Summary	Predadoor coil cord to wireless bottom bar retro				
Products Affected	Predadoor				
Key Word Tags	Wireless, Retro, Coil Cord,				
Tools/Equipment (If Required)					
Parts/Materials (If Required)	LH Wireless Bracket Assy R1060259-1, OR RH Wireless Bracket Assy R1060259-2 EPROM V02-05.38 R0111039 (If Required), Coupler Shaft, Feig RS703988, 3/8" Lock Washer R0554118, Flat Washer R5550015-0Z01, System 3 Control Board R00141006 (If Required), Bottom Bar Assy LH R1060057-1 OR Bottom Bar Assy RH R1060057-2				
Related Media					
Author	Mason Barnett, RevA M. Burzlaff	Issue Date	9/02/2011	Status	Active

PLEASE READ THE ENTIRE BULLETIN BEFORE PROCEEDING WITH RETRO

Figure 1

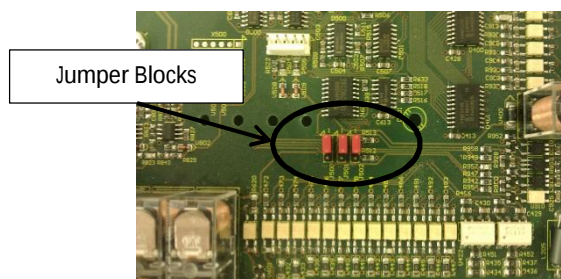
Customers requesting to convert from coil cord to wireless on their door will need to check the control board for encoder red block jumper availability. If the board has solder dots instead of jumpers, the board will need to be replaced. (See Figure 1).

Figure 2

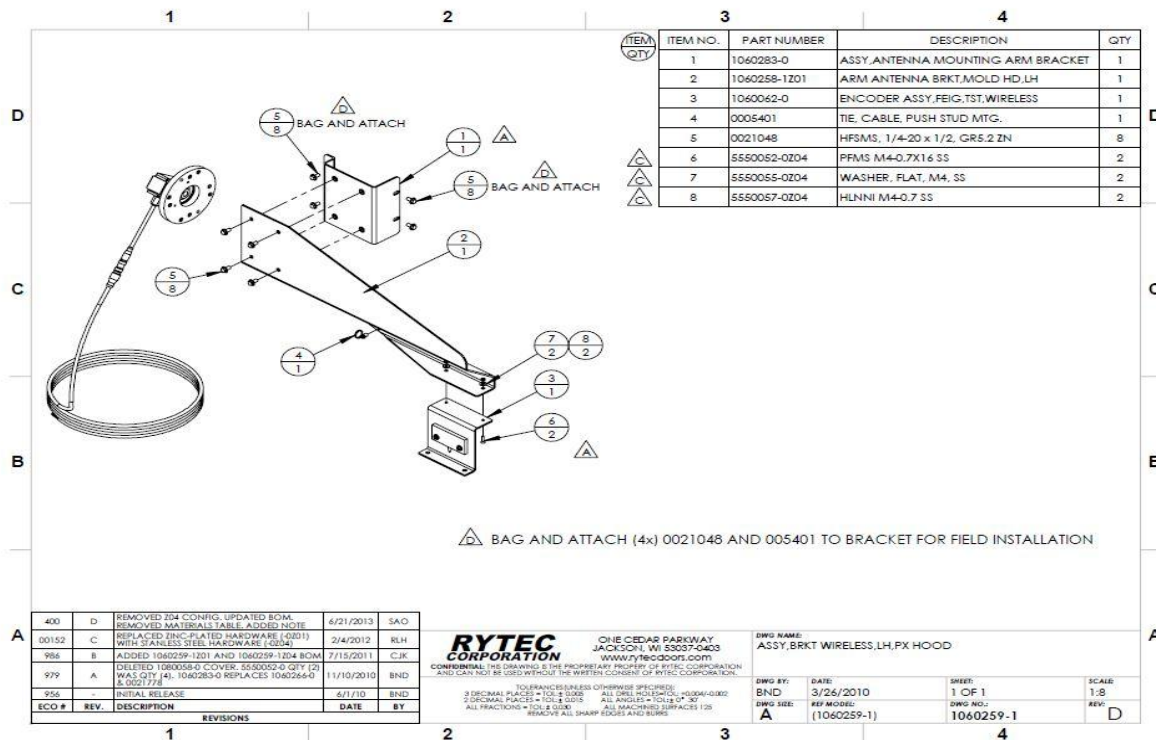
If the door was sent out prior to 11/1/03 and the board was never replaced and software was never upgraded, the customer will need get a new System 3 board. You will also need to check the drive side of the door to make the proper selection for the mobile unit antenna mounting bracket. (See Figure 2 for LH & Figure 3 RH Antenna Assemblies, Figure 4 Bottom Bar Assemblies).
